CLUNK OR POP-TYPE NOISE AND/OR BUMP FELT FROM FLOOR PAN WHILE TURNING LEFT OR RIGHT—BUILT ON OR BEFORE 5/1/2012	TSB 13-6-7
--	-------------------

2008-2012 F-Super Duty

This article supersedes TSB **10-25-3** to update the model years, production fix date and Service Procedure.

Figure 1 - Article 13-6-7

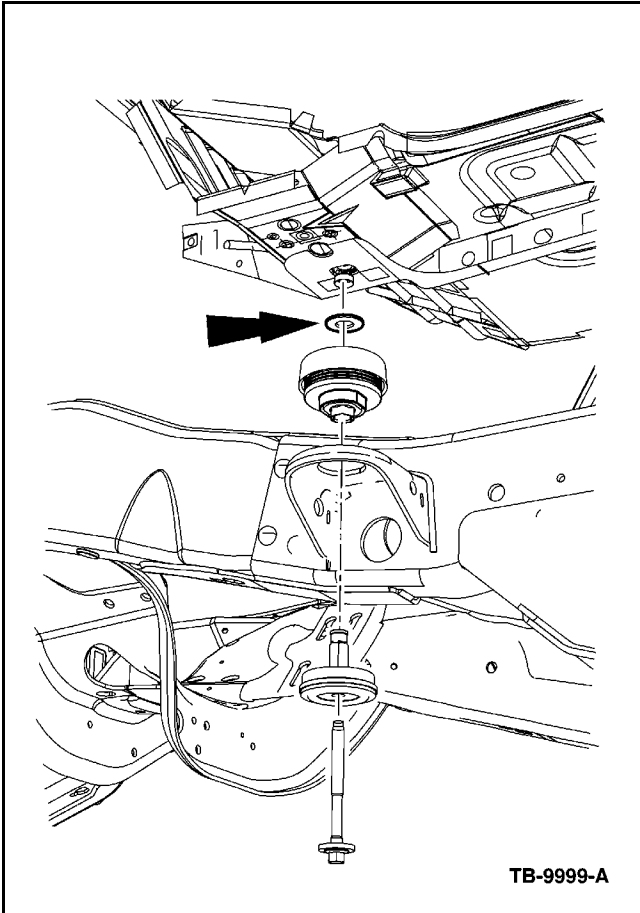
- a. Yes - proceed to Step 4.
 - b. No - this article does not apply. Refer to (WSM), Section 100-04 for normal diagnostics.
4. Determine vehicle model year and built date.
 - a. 2008-2010 vehicles proceed to Step 5.
 - b. 2011 and 2012 vehicles built on or before 05/01/2012 proceed to Step 13.
 5. Loosen all body support mount bolts from the affected side except the front end sheet mount located behind the front bumper.
 6. Raise vehicle cab slightly approximately 25 mm (1").
 7. Remove the number 1 body support mount(s) on the affected side of the vehicle only. Refer to WSM, Section 502-02.
 8. Use a wire wheel to clean all threadlock material from the threads of the bolts.
 9. Install a shim between the floor pan and number 1 upper body support mount that exhibits the noise. (Figure 1)

10. Lower vehicle cab.
11. Apply Motorcraft® Threadlock and Sealer to the threads of the body support mount bolts.
12. Reinstall the body support mount bolts number 2, 3 and 4 and torque to 103 N•m (76 lb-ft). Refer to WSM, Section 502-02.
13. Replace the No. 1 lower body support mount(s). Refer to (WSM) Section 502-02.
 - a. Apply Motorcraft® Threadlock and Sealer to the threads of all body support mount bolt(s).
